## ADDENDUM NO. 1

**DATE: June 26, 2015**

Contract 14-C-00042; Melrose Pump Station Rehabilitation

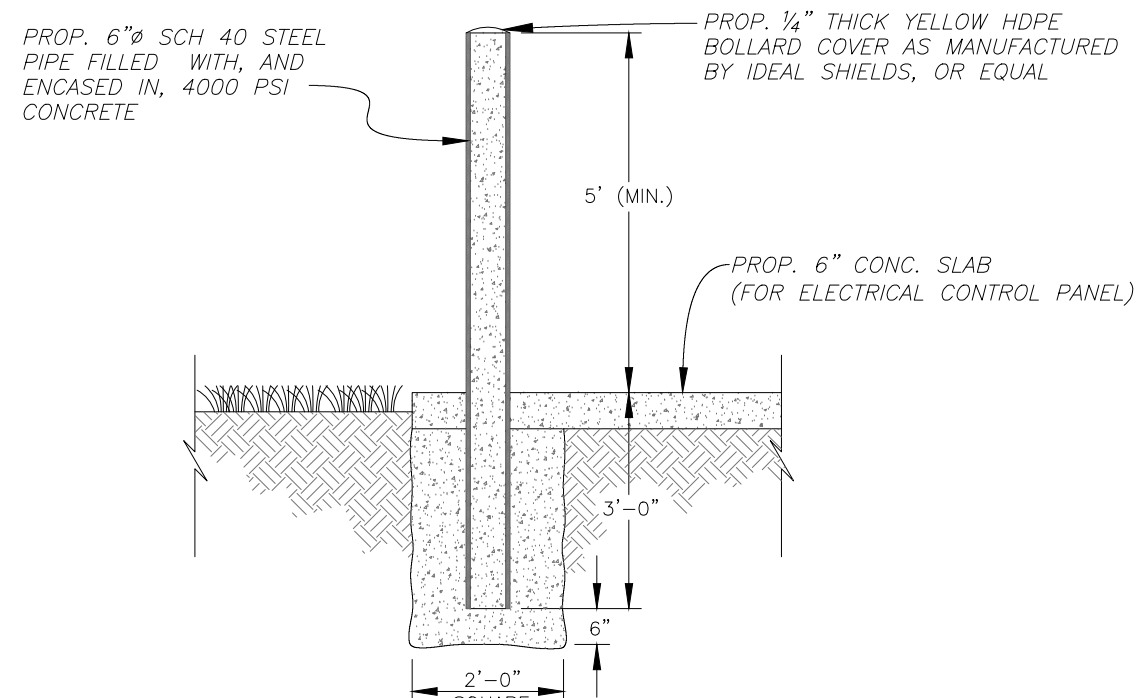
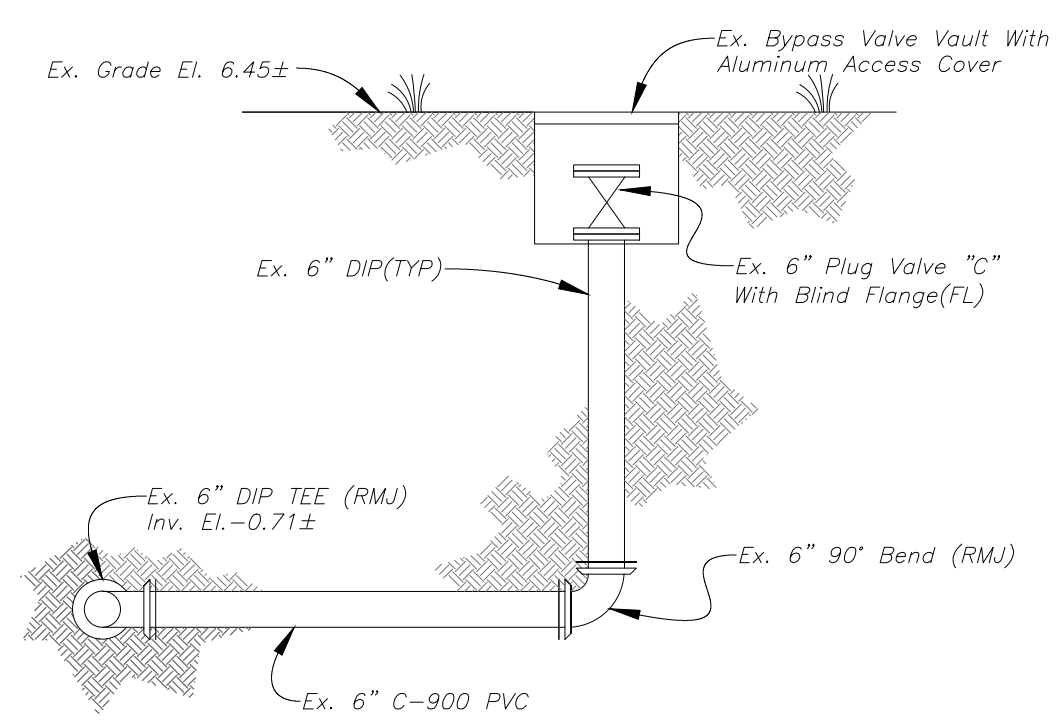
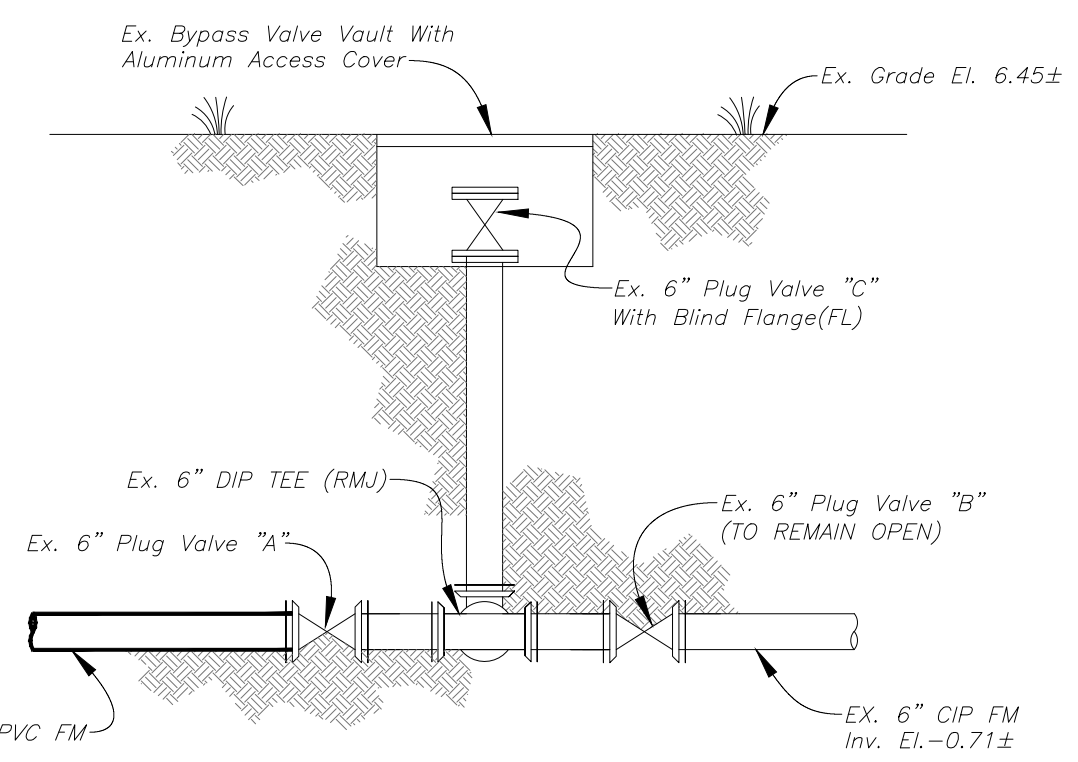
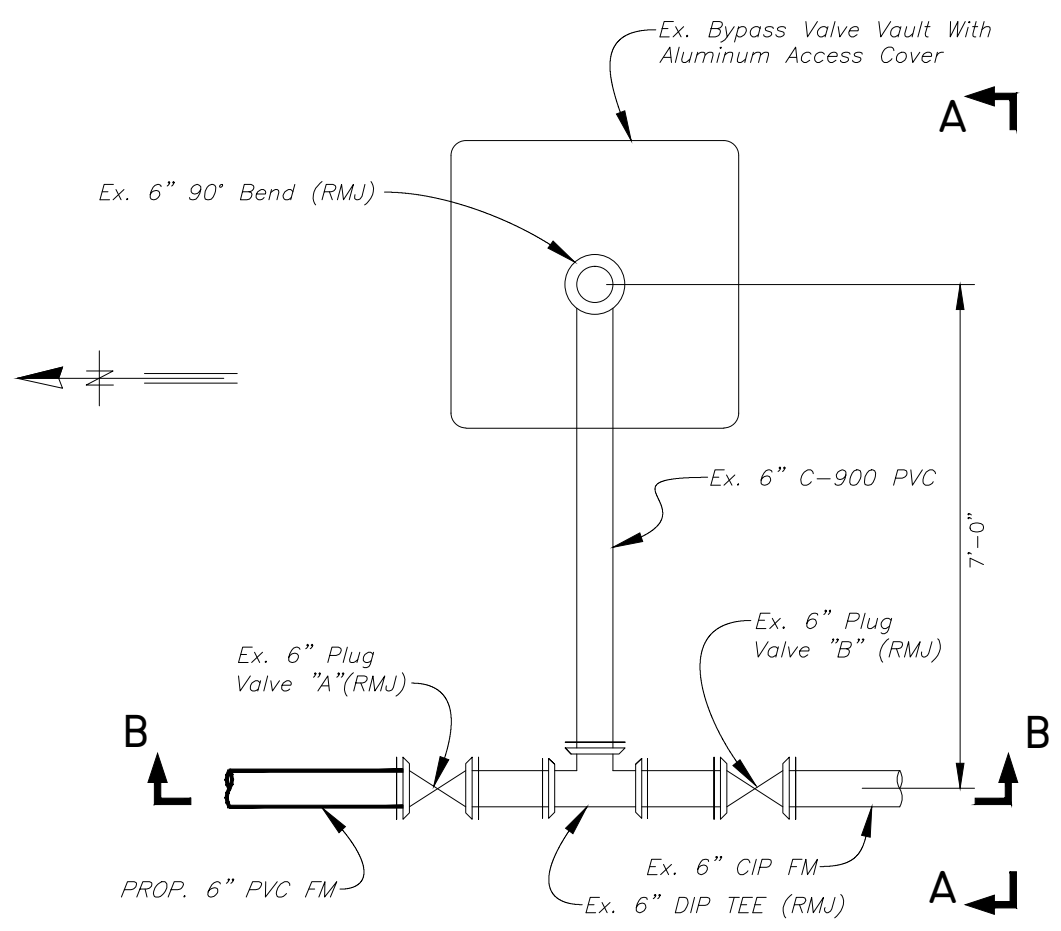
- 1) CONTRACTOR SHALL VERIFY ACTUAL POSITION OF PLUG VALVE "C" BEFORE REMOVING BLIND FLANGE. THE CITY BELIEVES THE VALVE IS IN THE CLOSED POSITION. VALVE "C" SHALL BE CLOSED PRIOR TO STEP 2.
- 2) REMOVE 6" BLIND FLANGE AND CONNECT TO EXISTING PLUG VALVE "C"
- 3) OPEN PLUG VALVE "C"
- 4) CLOSE PLUG VALVE "A"
- 5) PLUG VALVE "B" TO REMAIN OPEN
- 6) START-UP BYPASS SYSTEM

AFTER CONSTRUCTION IS COMPLETE AND THE NEW PUMP STATION HAS BEEN TESTED AND APPROVED, PLUG VALVE "A" SHALL BE OPENED AND PLUG VALVE "C" SHALL BE CLOSED AND BLIND FLANGE INSTALLED.

JACINTO CARLOS FERRAS, P.E. #49454 DESIGN DIVISION HEAD WASTEWATER DEPARTMENT	No.	DATE	REVISIONS	DES: CB	CITY of TAMPA WASTEWATER DEPARTMENT	MELROSE AVE. PUMPING STATION REPLACEMENT EXISTING BYPASS VALVE VAULT AND BOLLARD DETAILS	W.O.1000061 SHEET 19
	3			DRN: BB			
	2			CKD:			
	⚠	06/26/15	THIS SHEET ADDED BY ADDENDUM	DATE:
